NOTICE OF A TYPE II DECISION ON A PROPOSAL IN YOUR NEIGHBORHOOD

CASE FILE NUMBER: LU 16-129919 HR – NEW WIRELESS FACILITY CONCEALED IN FAUX WATER TOWER

Case Type: HR – Historic Resource Review

SHEET TITLE:
ROOF PLAN

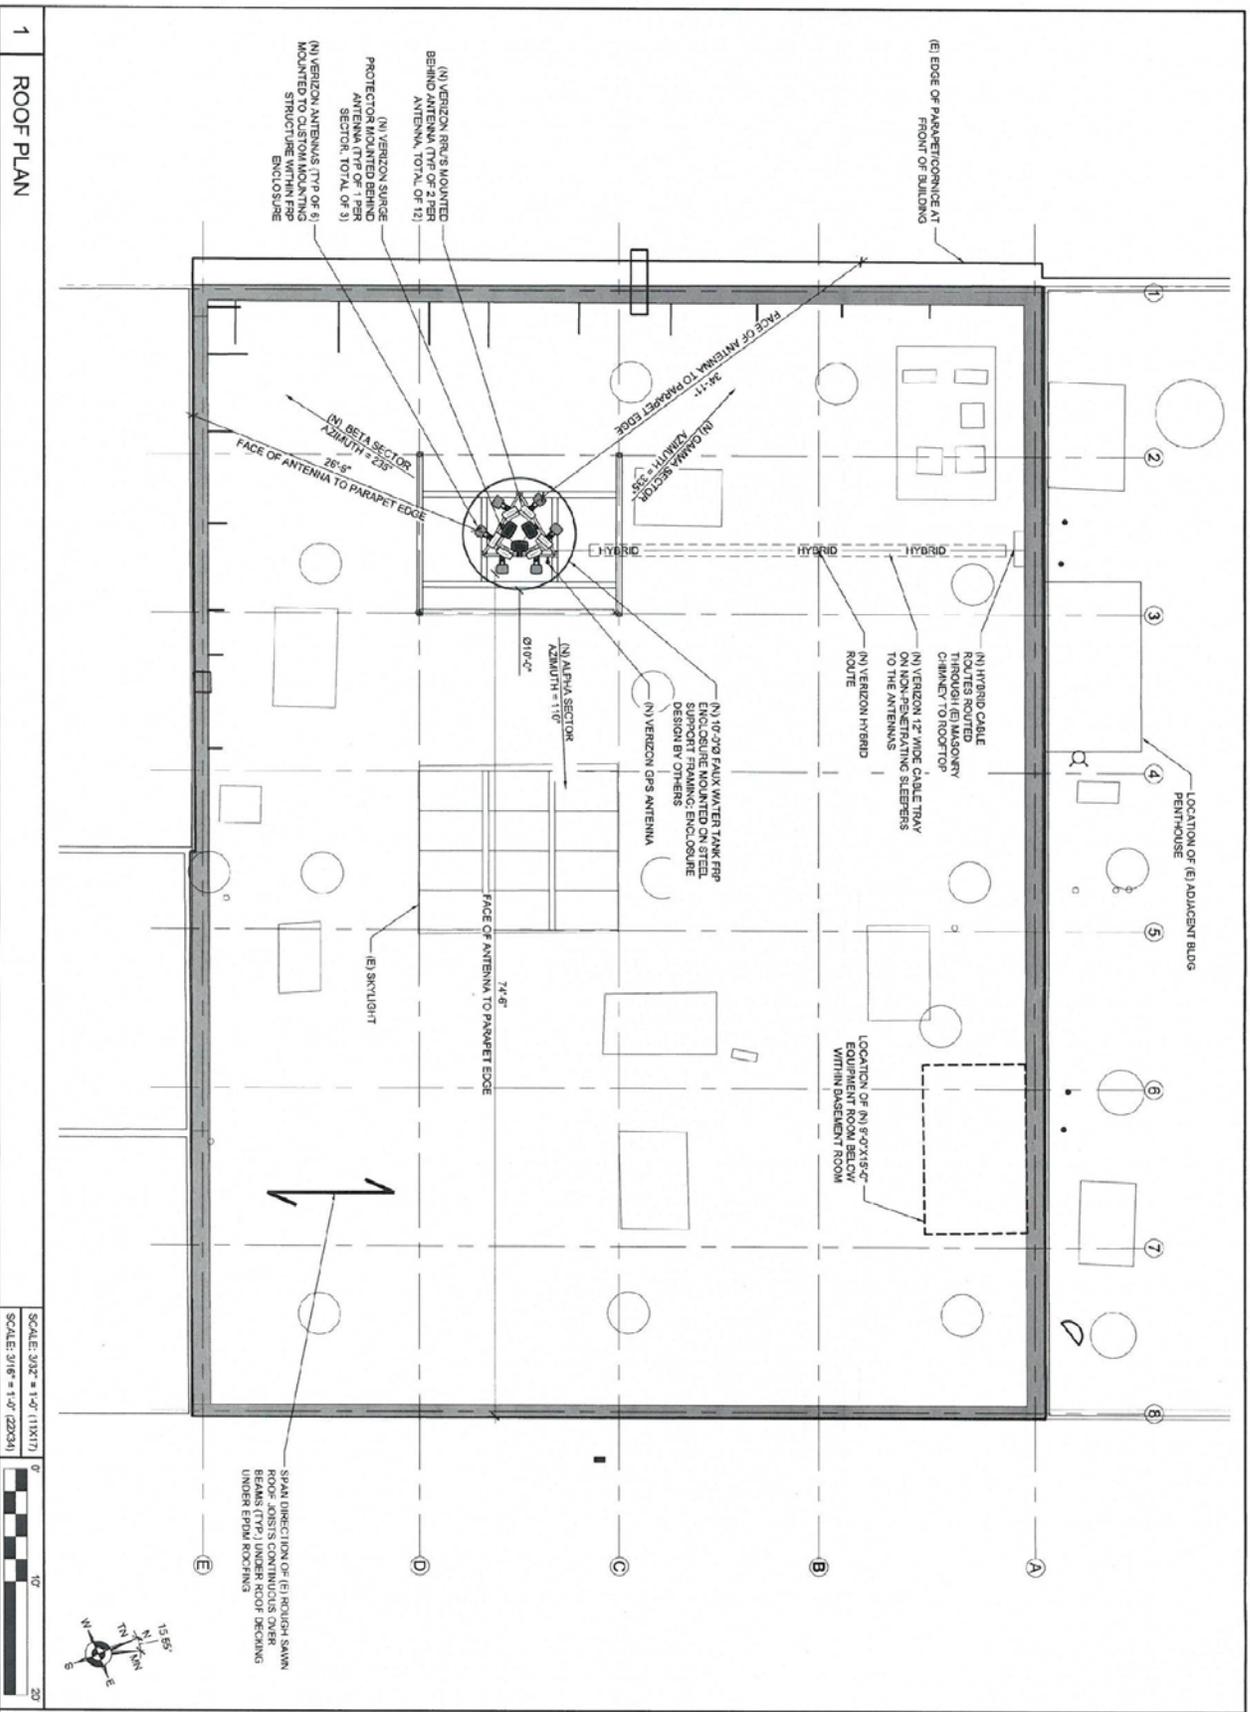
While the proposal does not include a vertical or horizontal addition that adds floor area, the proposed faux water tower consists of a fiber reinforced plastic (FRP) tank approximately 10' in diameter and 9'-6" tall supported by a 7'-9" tall steel structure, for a maximum total height of 17'-3" from the surface of the roof deck to the top of the tower. This element adds mass to the top of the roof that will be highly visibly from the adjacent rights-of-way and does not respond to the massing of traditional rooftop additions commonly seen on a building of this size in the District, such as stair overruns or mechanical penthouses.

As proposed, the inclusion of a rooftop element of this size and placement does not meet the guidelines above and is not supportable. If the massing of the proposal was reduced to the height and width of similar roof top elements that are common on building of this size in the District, and if the proposed antennas and shroud were located with a significant setback from both the west and south property lines (along SW 1st and adjacent to the Landmark Seufert Building, respectively) so that alterations were not visible from the adjacent rights-of-way, the proposal could potentially meet the approval criteria.

For the reasons stated above, these approval criteria are not met. The proposed massing and the proximity of the antennas and shroud to both the south and west roof edges ensure high visibility from adjacent rights-of-way, which have an impact on both the resource and the District as a whole in terms of detracting from the pedestrian environment, compromising architectural integrity, and detracting from the experience of the Skidmore/ Old Town Historic District, one of only two nationally listed Historic Landmarks in the City. *Therefore, these guidelines are not met.*

The rooftop addition proposed is not appropriately sized with respect to utilitarian roof top additions commonly seen on buildings this size in the District, such as stair overruns and mechanical penthouses, and is not placed to limit visibility from adjacent rights-of-way. In addition, the proposal to install a RF transparent shroud that mimics the look of a historic water tower, does not complement the context of existing buildings and does not achieve a coherent composition. As such, the proposed inclusion of a rooftop addition of this size, placed in a way that ensures high visibility from adjacent rights-of-way, is not appropriately sized, and the use of a RF transparent shroud that has been designed to mimic the look of a historic water tower on a building that has never had a water tower, contribute to this proposal not meeting the approval criteria.
